*BEACON PLANNING BOARD*  
*Via Video Conference*  
*BEACON, NEW YORK 12508*  
*Phone (845) 838-5002 Fax (845) 838-5026*

The Planning Board will meet on **Tuesday, April 14, 2020** in the Municipal Center Courtroom. Due to public health and safety concerns related to COVID-19, the Planning Board will not be meeting in-person. In accordance with the Governor's Executive Order 202.1, the April 14, 2020 meeting will be held starting at 7:00 PM via videoconferencing, and a transcript will be provided at a later date. The public can watch the live meeting online at YouTube at [www.youtube.com/channel/UCvPpigGwZdeR7WYmw-SuDxg](http://www.youtube.com/channel/UCvPpigGwZdeR7WYmw-SuDxg). If any interested members of the public would like to provide comments on the application, comments can be called in during the meeting at (929) 205-6099. Webinar ID: 254 824 895 Comments can also be provided via email no later than 5PM on April 14, 2020 to Etha Grogan, Planning Board Secretary, at [egrogan@cityofbeacon.org](mailto:egrogan@cityofbeacon.org). Please check the meeting Agenda posted on the City website ([www.cityofbeacon.org](http://www.cityofbeacon.org)) for further instructions to access the

**Special Use Permit Application**  
Sheet 1 of 2 - Site Plan

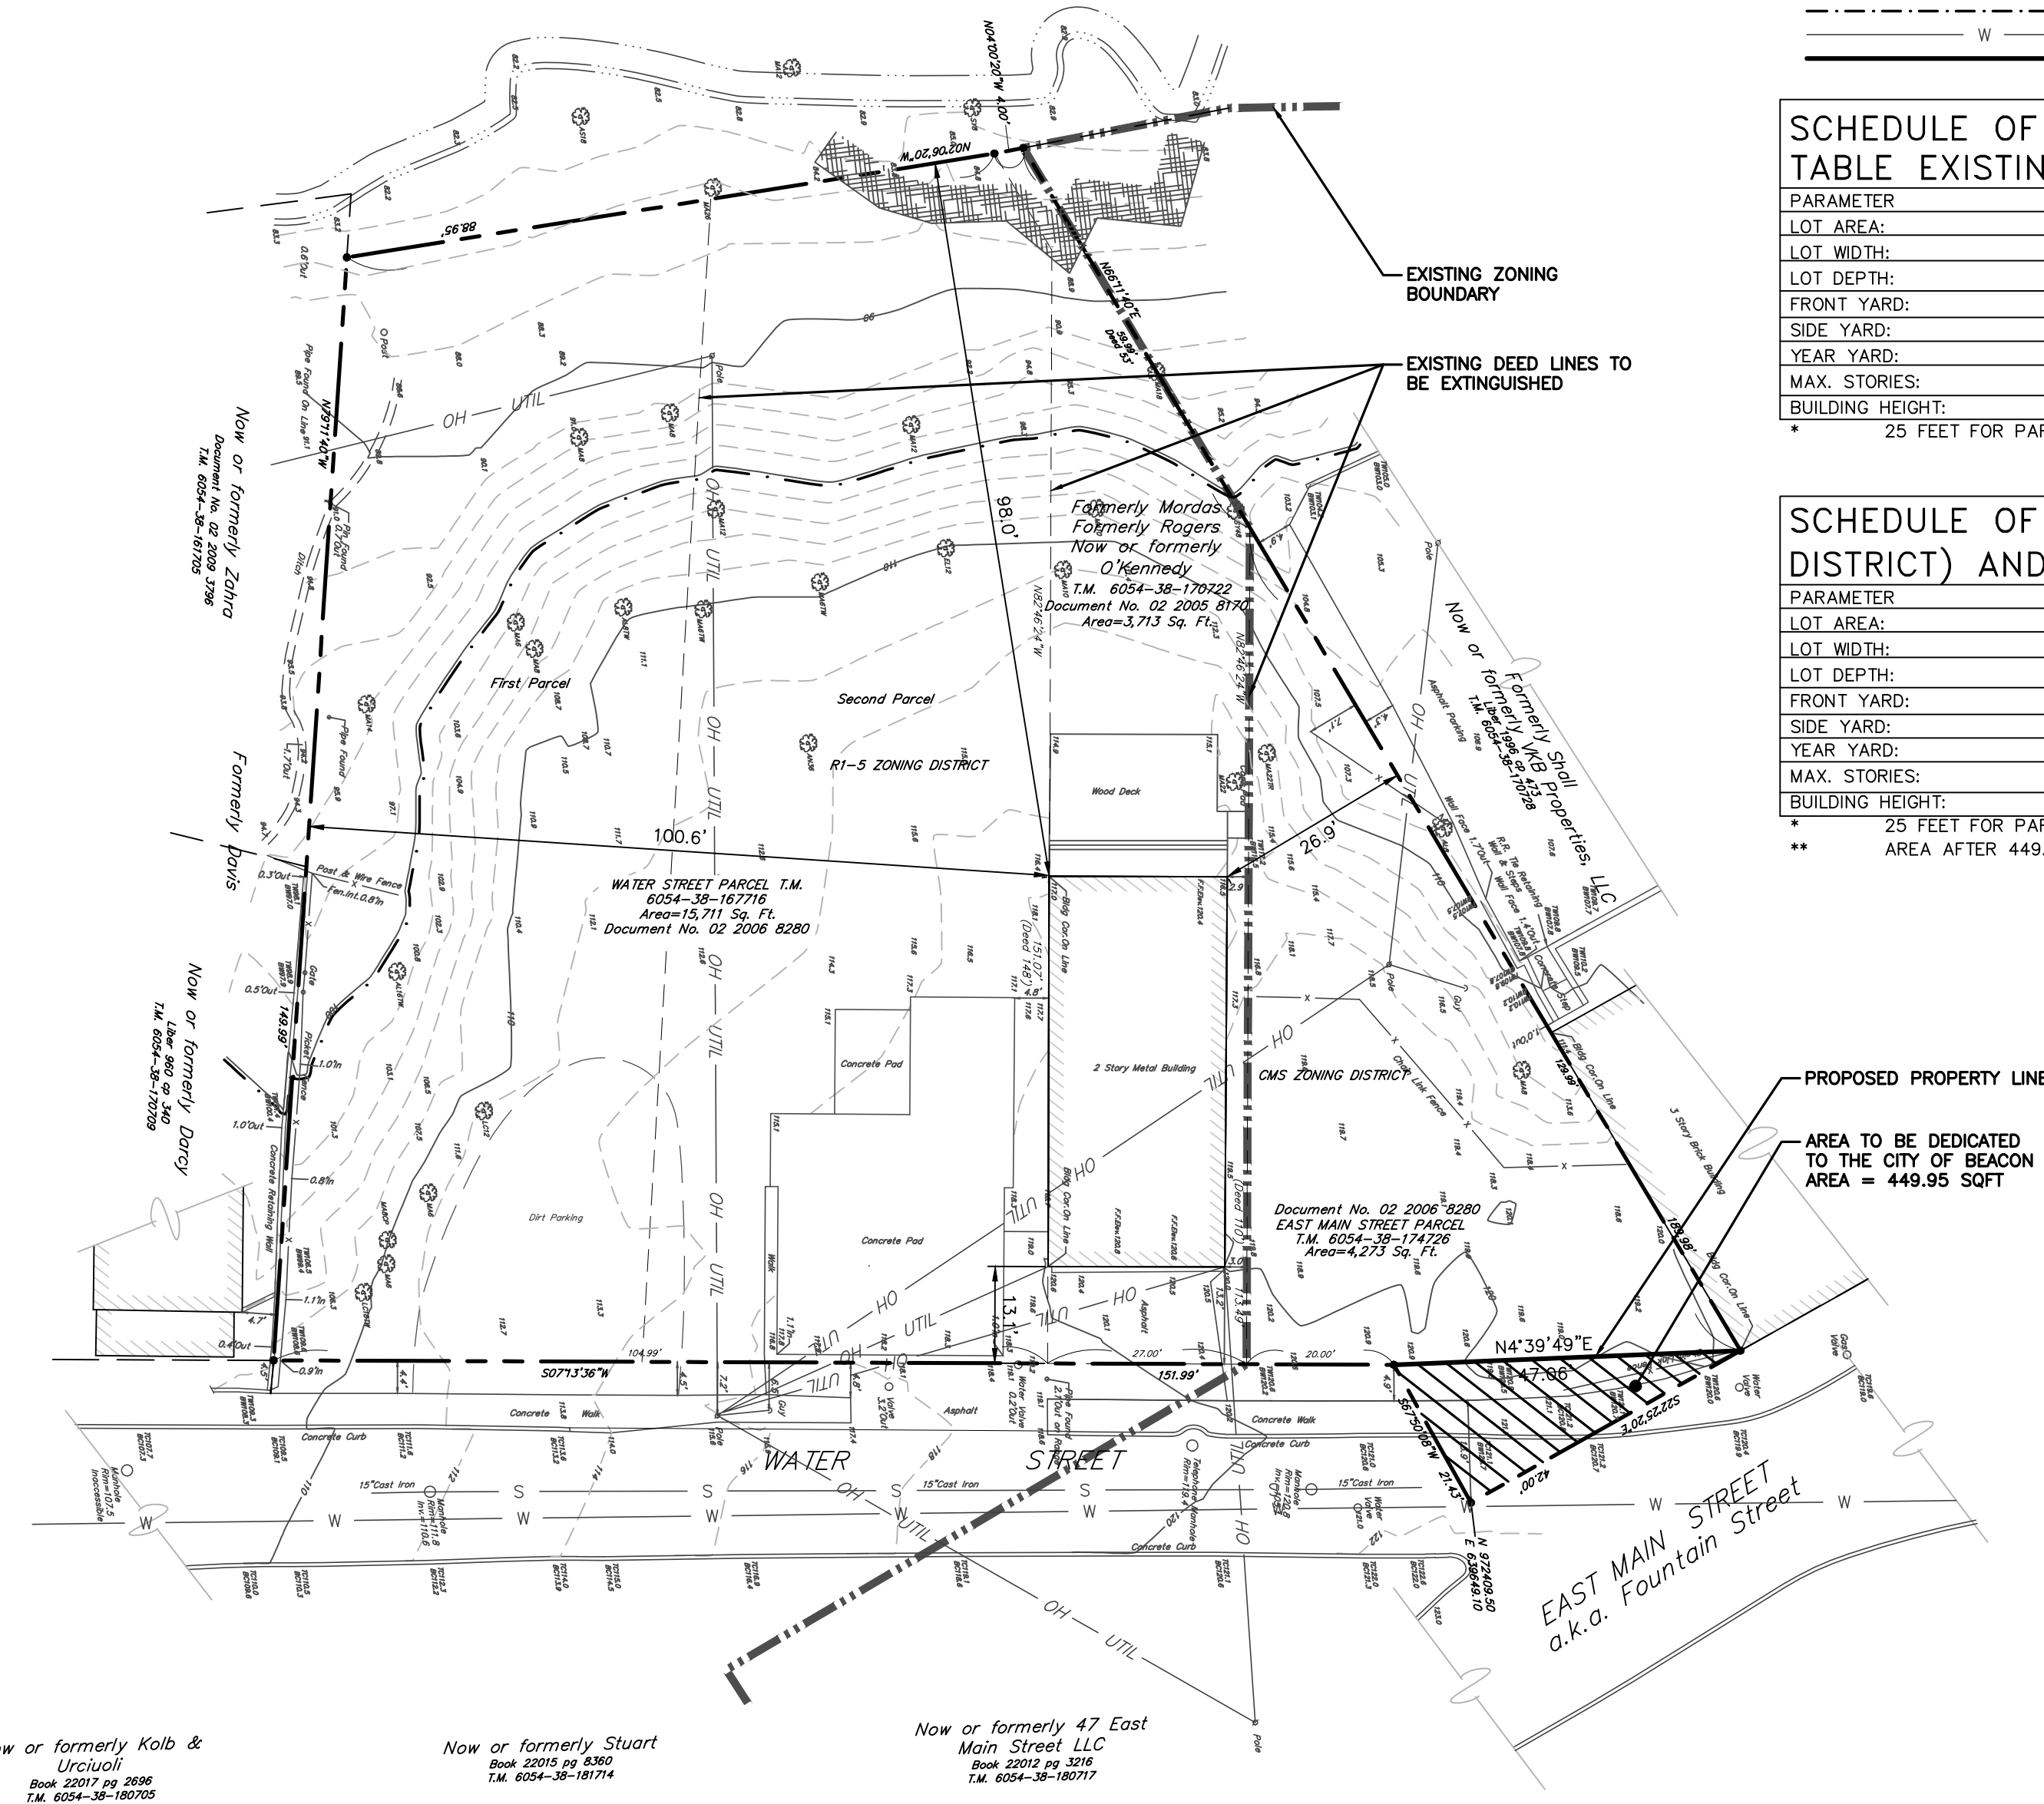
3. For Sheet 1, the site area is shown twice on the plan with different numbers. The lot square footage should match the Subdivision Plat. Also, the titles should be updated to Sheet 1 of 6.

**Special Use Permit Application**  
Sheet 2 of 2 - Existing Conditions / Site Demolition Plan

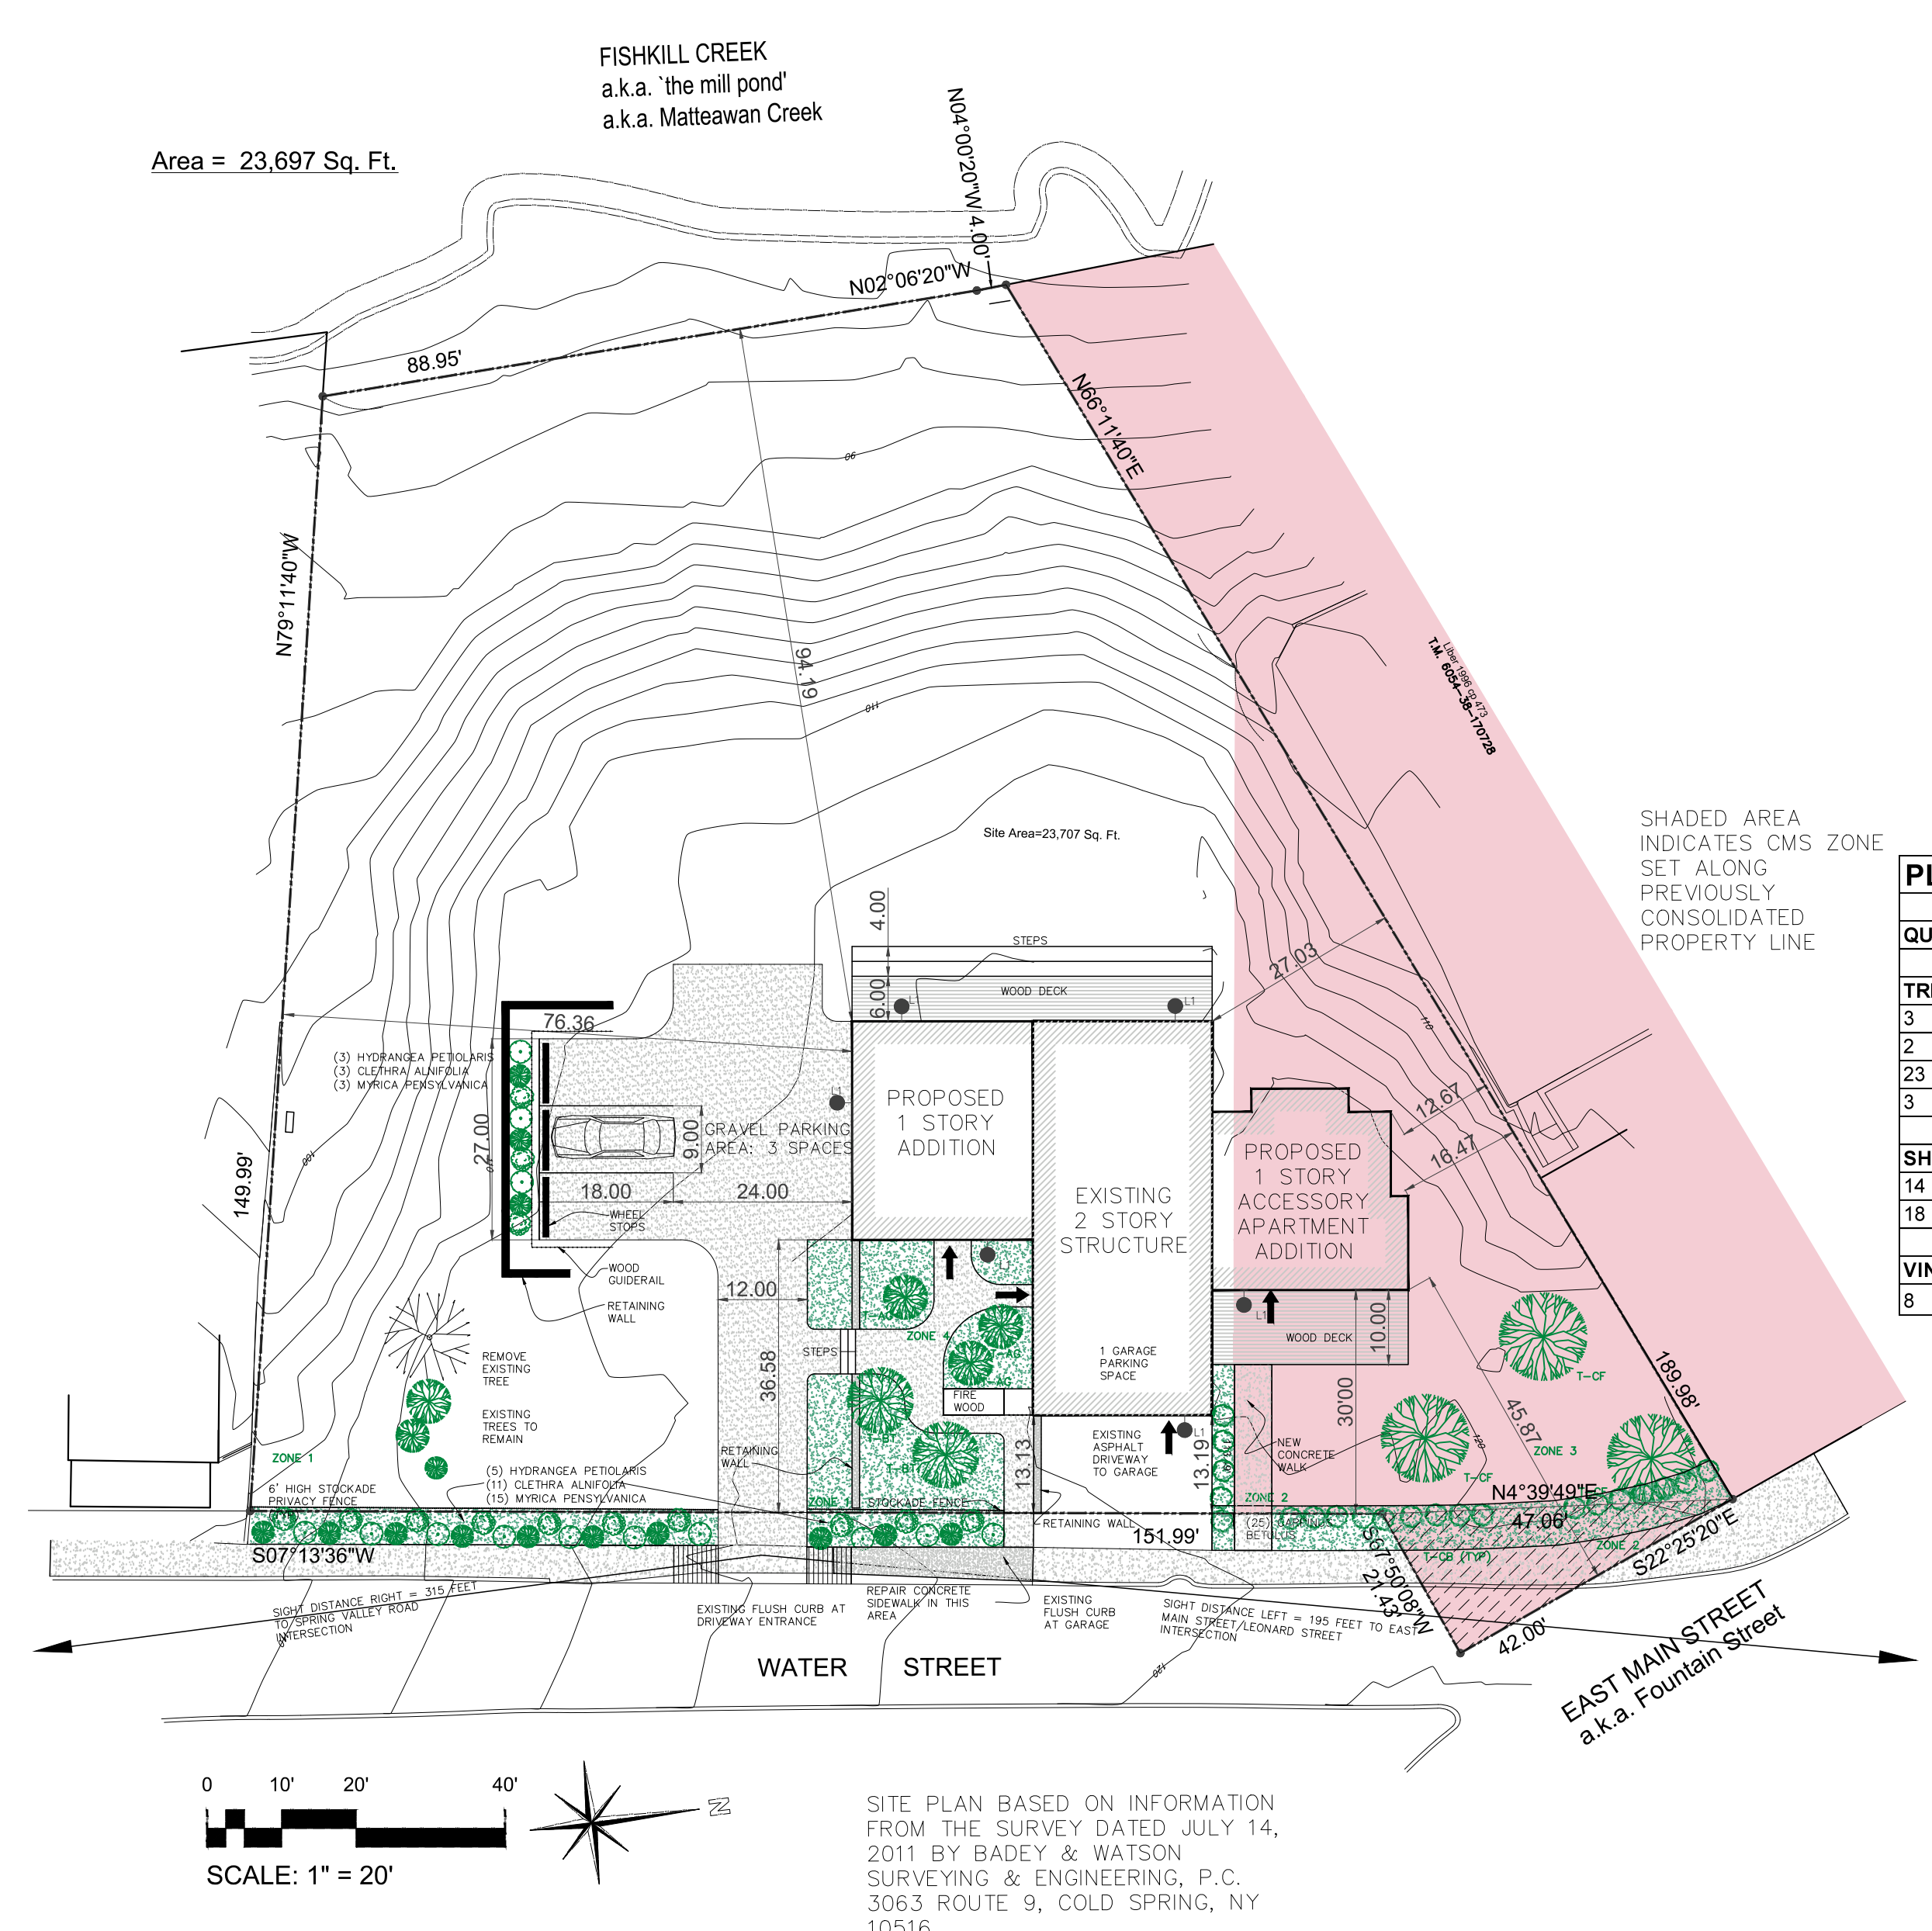
4. For Sheet 2, the existing chain link fences north of the house should be marked for removal.
5. The plans should clearly show the location of the new stockade privacy fence along the frontage. Front yard fences are typically limited to four feet high, but the Board has the discretion to approve the proposed six-foot fence where necessary for screening purposes (see §223-13 G(1)).
